The Shanin Corporation Ltd

Observations

Building 1: High Column Loads

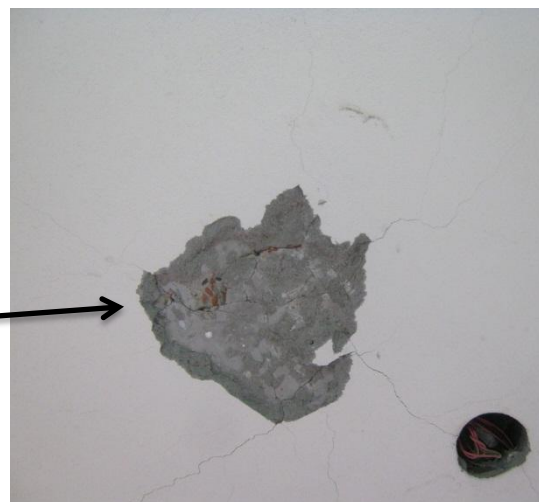
Building 1: Concrete Stress Levels in Columns

Preliminary calculations indicate that column working stress is at a high level in Building 1. Significant loading was observed arising from the additional rooftop factory area and the concrete water tank, and in particular columns supporting large bays and cantilever structures were found to be highly stressed.

A **Detail Engineering Assessment** of the building is required (see attached scope). The engineer is to perform detailed calculations based on the as-constructed structural arrangement, material properties and loading to verify column size suitability. If required, column loading shall be reduced, and columns possibly strengthened.

6	Building 1 - Verify load capacity of all columns	Detail Engineering Assessment to be completed	6-weeks
7	Building 1 - Verify load capacity of all columns	Produce as-constructed general arrangement structural drawings	6-months
8	Building 1 - Verify load capacity of all columns	Continue to implement load plan	6-months

Building 1: Apparently non-engineered opening in Ground Level slab

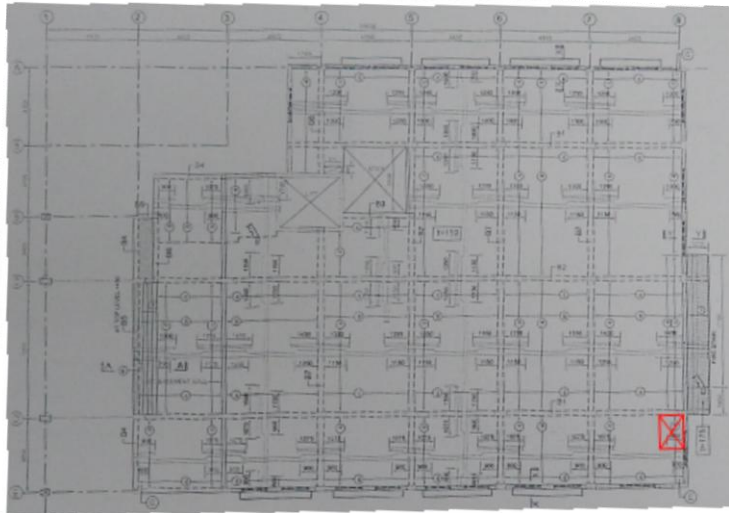
Building 1: Apparently non-engineered opening in ground level slab

An opening has been formed in the ground level (suspended) slab for the insertion of stairs down to the basement. Cut ends of the reinforcement bars are exposed. Cracking was observed in the soffit of the Ground level slab from the corner of the new opening near the centre of the slab panel.

13	Building 1 - Apparently non-engineered opening formed in Ground Level slab for insertion of new Basement stairs	Engineer to advise on load repair and strengthening of the slab if required	6-weeks
14	Building 1 - Apparently non-engineered opening formed in Ground Level slab for insertion of new Basement stairs	Engineer to specify measures to reinstate corrosion protection to ends of exposed cut slab reinforcement	6-weeks
15	Building 1 - Apparently non-engineered opening formed in Ground Level slab for insertion of new Basement stairs	Implement actions arising from engineering assessment	6-months
